TOW FRIENDLY FRONT CLIP

OVERVIEW

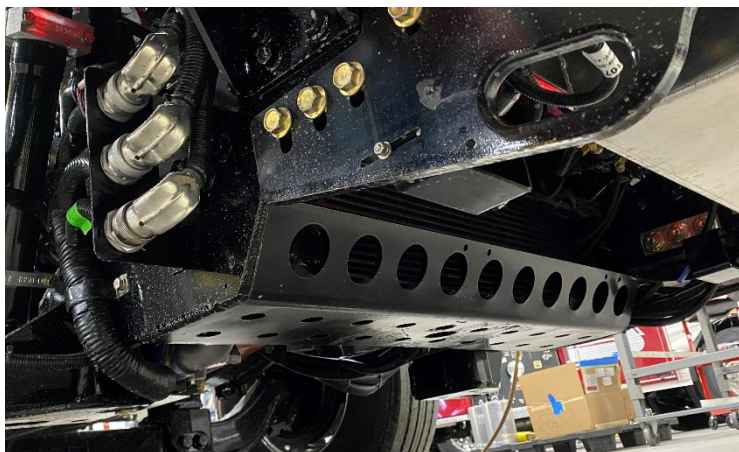
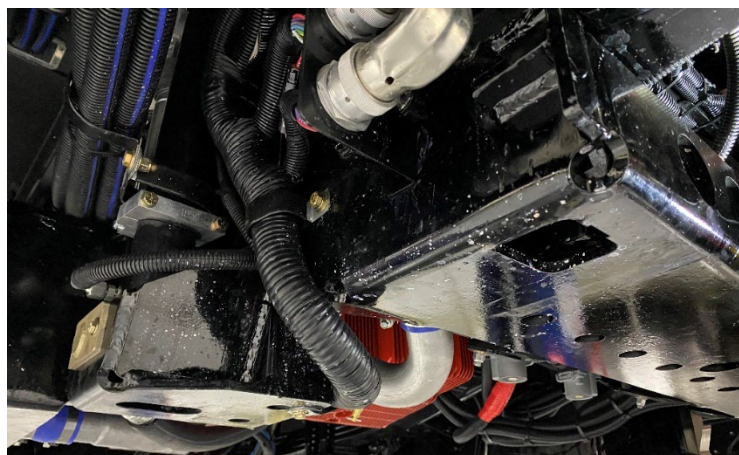
Sutphen chassis engineering has developed a new front clip that will be wrecker/tow truck friendly beyond the traditional tow eyes. A selectable option for the tow friendly front clip is now selectable. This will replace the standard front bumper clip that is called out in SQS2 as standard. The new tow friendly front clip allows for an accessible lifting point for tow trucks behind the standard tow eye location. The updated front clip is designed to be used with the U-shaped lift hardware to grab from the front (illustrated on next page).

45040100 FRONT BUMPER CLIP - STD

45040110 TOW FRIENDLY FRONT CLIP - IPOS
